SUBJECT: Forwards responses to Questions 1,2,3,5, & 6 of SEP Topic  
 VI-7.B re ESF switchover, per 810227 ltr.

Subject: SEP Topic VI-7.B, "ESF Switchover"  
R. E. Ginna Nuclear Power Plant  
Docket No. 50-244

Attachment: Additional Information Requested  
By February 27, 1981 Letter Regarding  
SEP Topic VI7.B, "ESF Switchover"

AUXILIARY COOLANT SYSTEM  
ENGINEERING FLOW DIAGRAM

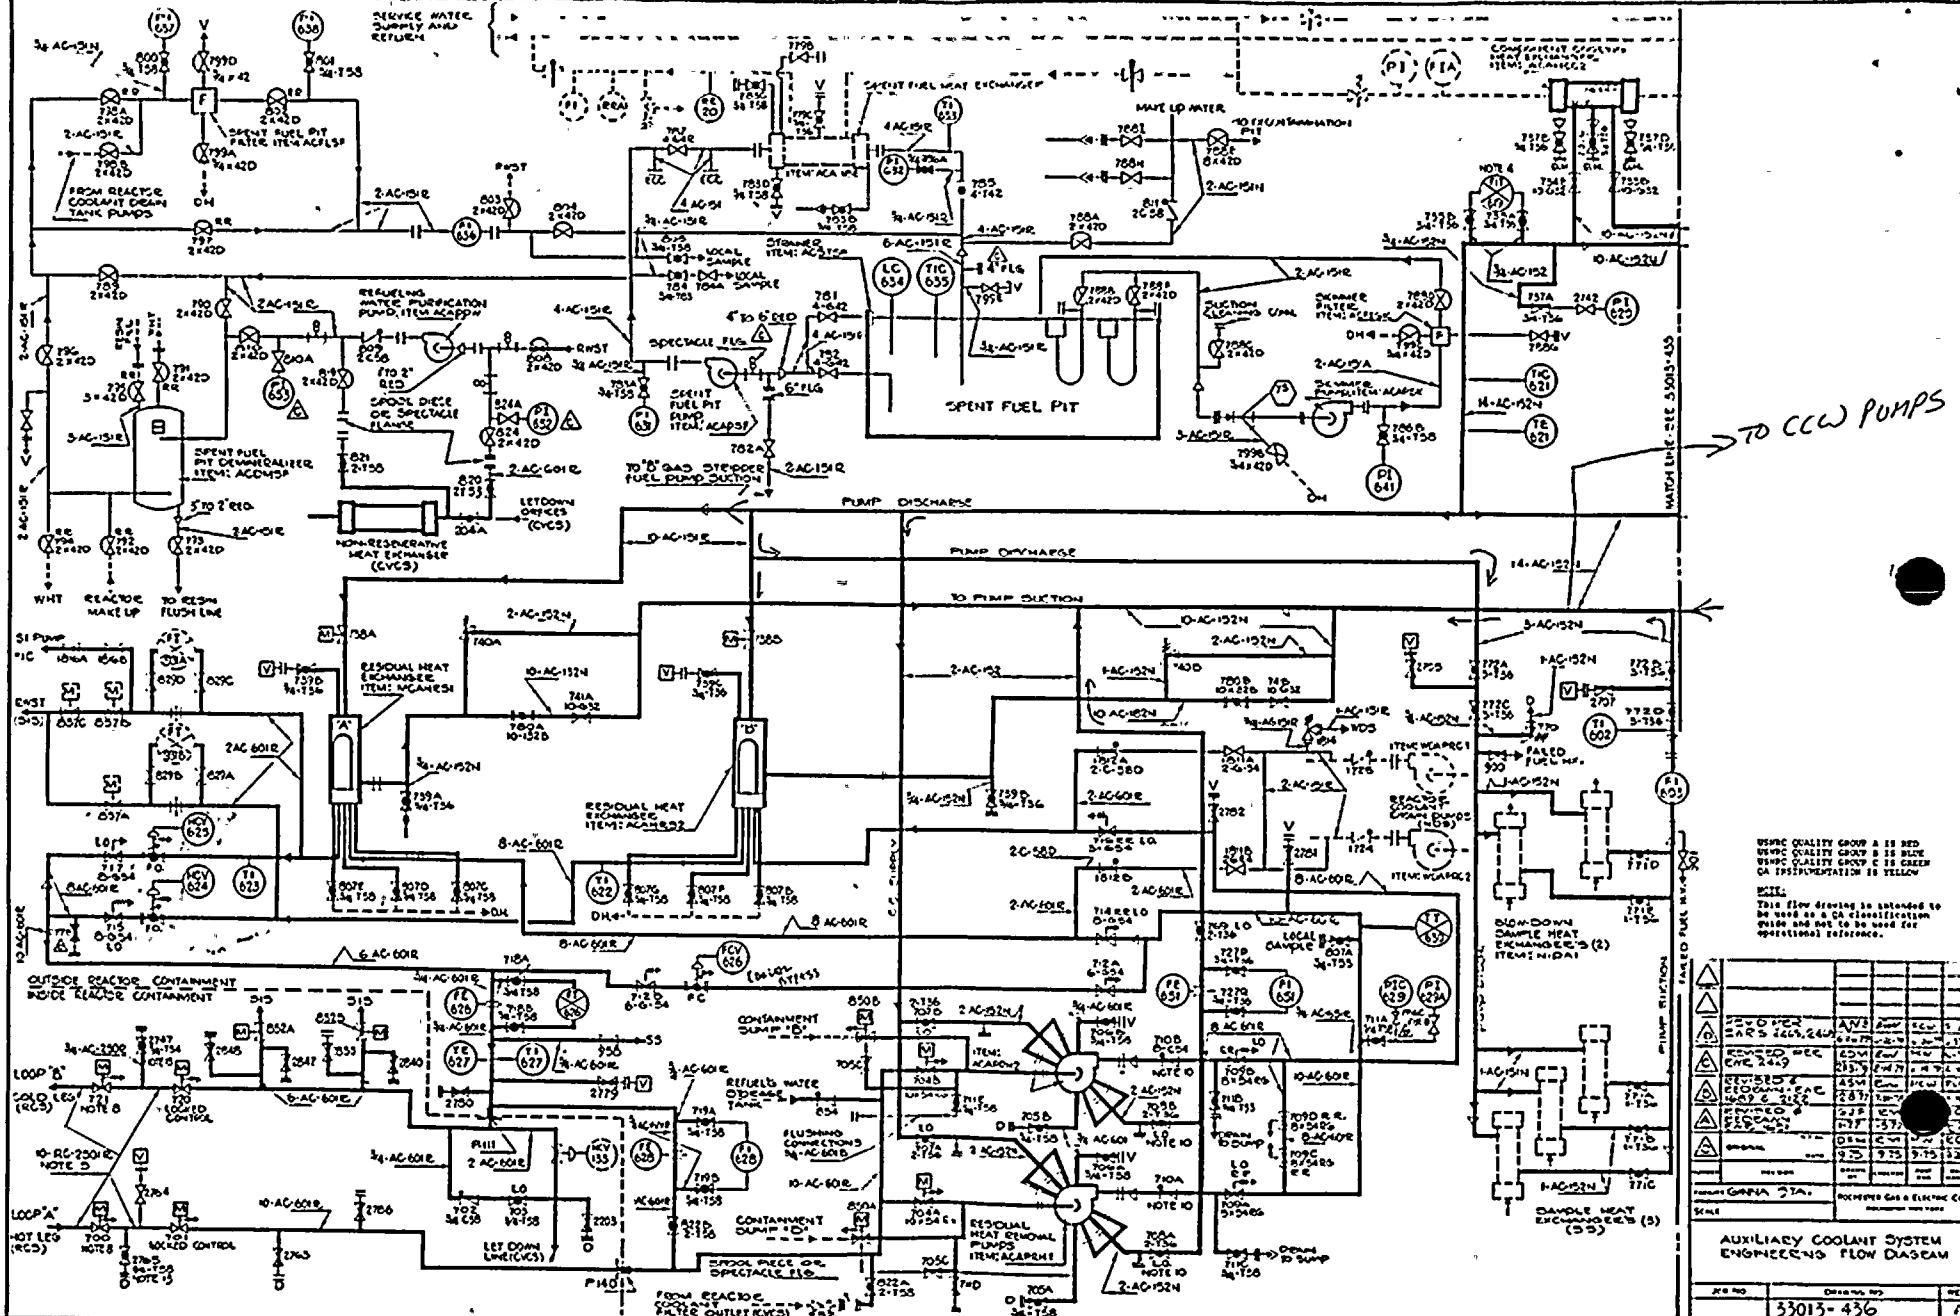
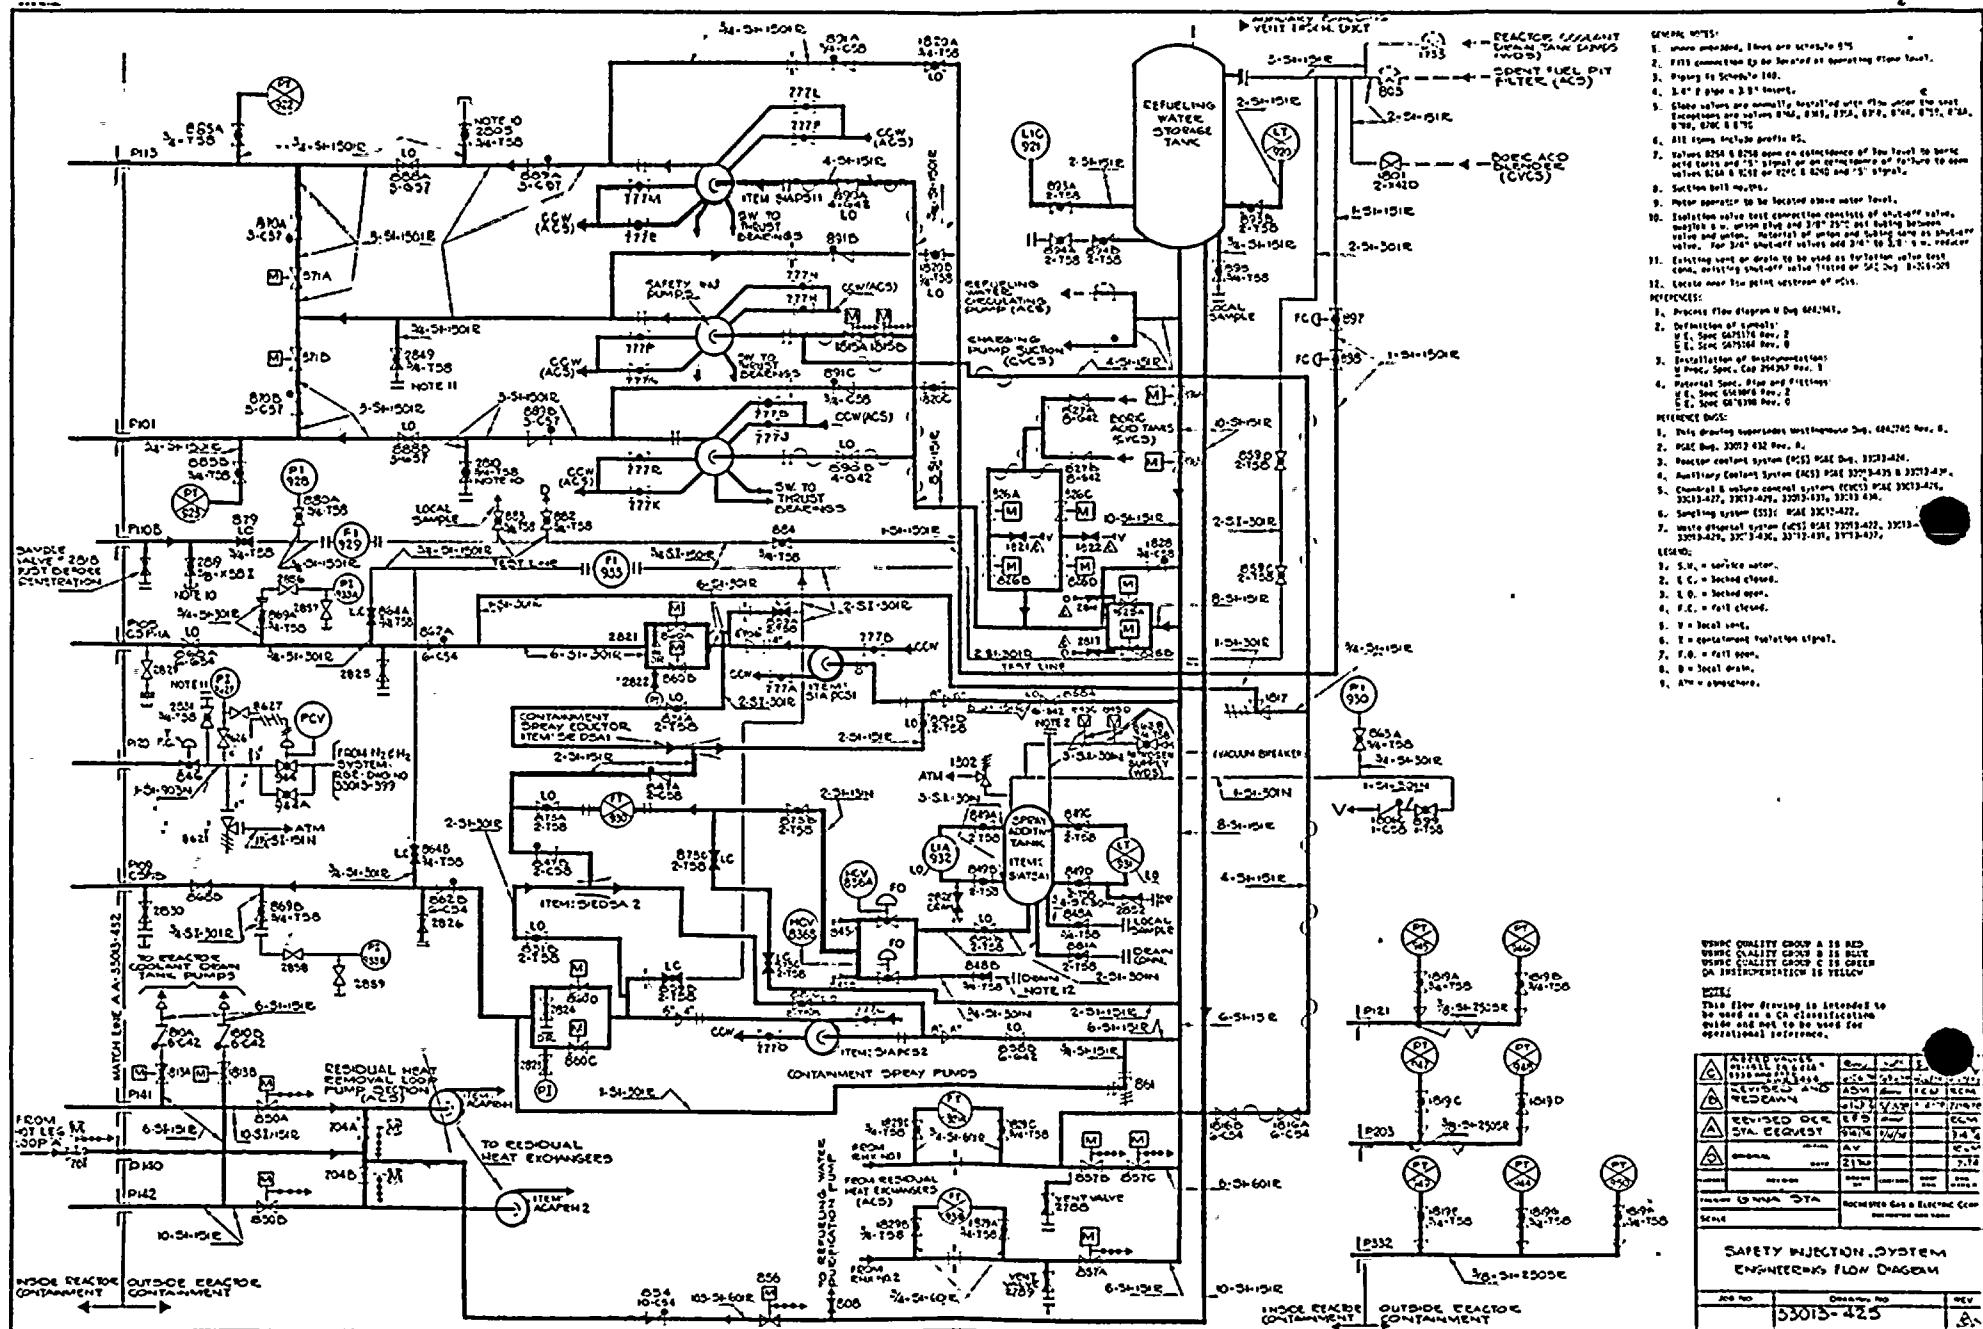
- (5) Describe the paths of the minimum flow lines from each ECCS pump discharge to the line end. This description should identify all valves in these lines, the signals that control each valve, the power sources for each valve, and the qualification of each valve.

Response 5: The flow paths for these pumps are shown on RG&E drawings 33013-425, Safety Injection System, and 33013-436, Auxiliary Coolant System (attached).

The safety injection pumps each have a minimum flow line returning to the RWST. The three lines join upstream of two series air-operated valves, AOV 897 and AOV 898. These valves do not receive an actuation signal; however, they are interlocked with motor-operated valves 857A, B, and C such that the discharge of the RHR pumps cannot be connected with the suction of the SI pumps until AOV 897 and 898 are closed. The solenoid AOV 897 is powered from instrument bus 1B; AOV 898 from instrument bus 1D. These valves fail-closed on loss of power or air.

The Containment Spray pumps have a recirculation line from the discharge to the suction of the pumps, with manual locked-open valves. The RHR pumps recirculate from the discharge of the pumps through the RHR heat exchangers, and through a common line via recirculation orifice FE 628 to the suction of the pumps. There are no valves in the recirculation path.

GINNA STATION INSTRUMENT  
BUS ELECTRICAL ONE LINE

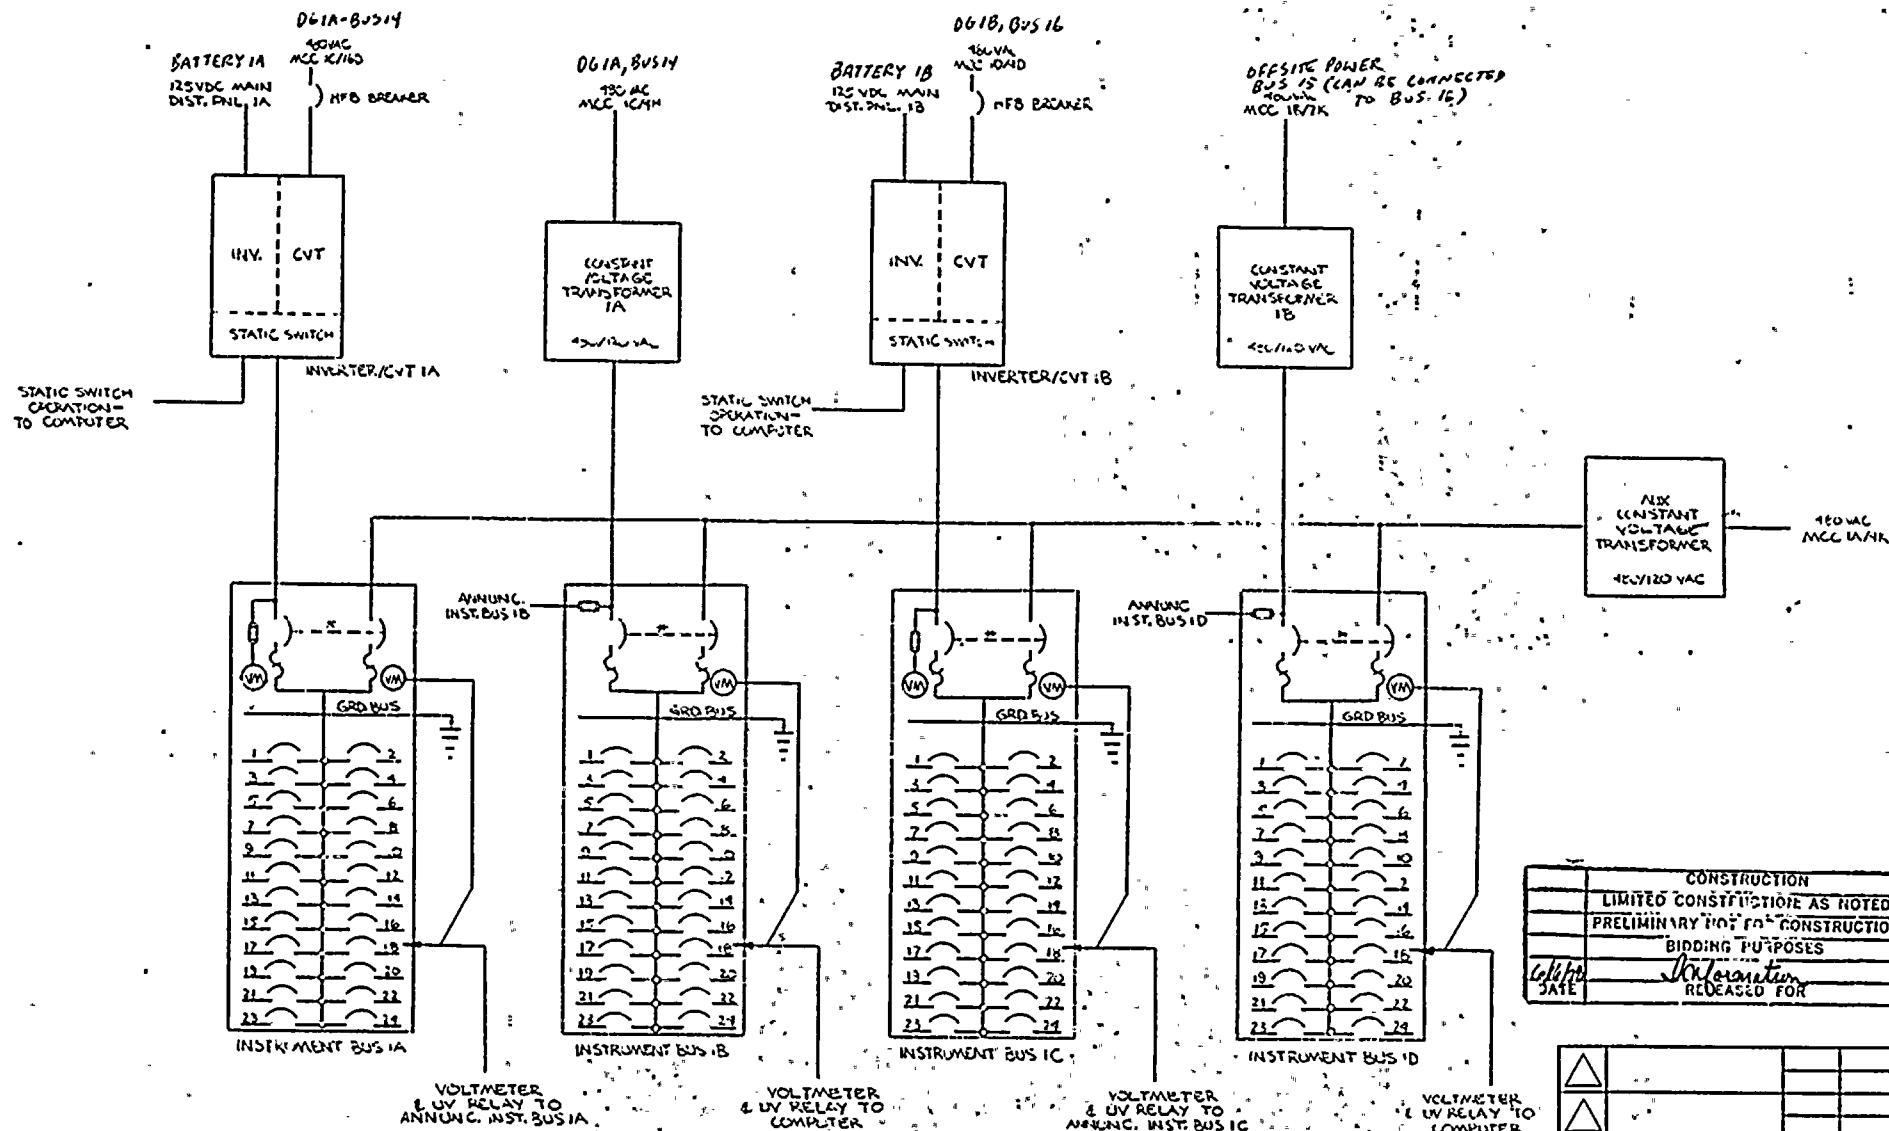
- 1) Check spray additive (NaOH) tank level LT-931 and LIA-932
  - 2) Check containment pressure PT-944-950
  - 3) Open valves MOV 857A, B, C - RHR to SI and CS pump suctions
  - 4) Start Containment Spray Pump(s) 1A and/or 1B
  - 5) Check NaOH flow FI-930
  - 6) Check RHR and CS flows FI-931A, 931B, 626
- (2) For each instrument, indicator, logic device and alarm that is used by the operator to perform a manual function or that is used to initiate an automatic function in the switchover sequence; describe how that device is qualified and installed (e.g. independence and separation of circuits) as Class 1E equipment.

Response 2: All indications required by the operator to perform a safety-related function have redundant or diverse components. The instrument bus electrical one-line diagram, RG&E drawing #21489-269 showing power supply arrangements, is attached.

- 1) RWST level, LT-920, on instrument bus 1C (IB1C), is backed up by level indicating alarm LIA-921 on the annunciator power transformer (normally fed from battery 1A).
- 2) RHR flow FI-626, on IB1C is backed up by RC wide range pressure PR-420 on IB1D. Instrument bus 1D, although fed from non-safeguards bus 15, is procedurally connected to safeguards bus 16 if offsite power is lost prior to the time that RWST-to-sump switchover would be required.
- 3) SI flow FI-924, on IB1A and FI-925, on IB1B, are redundant
- 4) NaOH tank level LT-931, on IB1C is backed up by LIA-932 on IB1B.
- 5) There are seven containment pressure indications PT-944 to PT-950 on redundant power sources.
- 6) NaOH flow FT-930 on IB1C is backed up by tank level LIA-932 on IB1B.
- 7) RHR flow to suction of CS and SI pumps FI-931A on IB1C and FI-931B on IB1B are redundant.
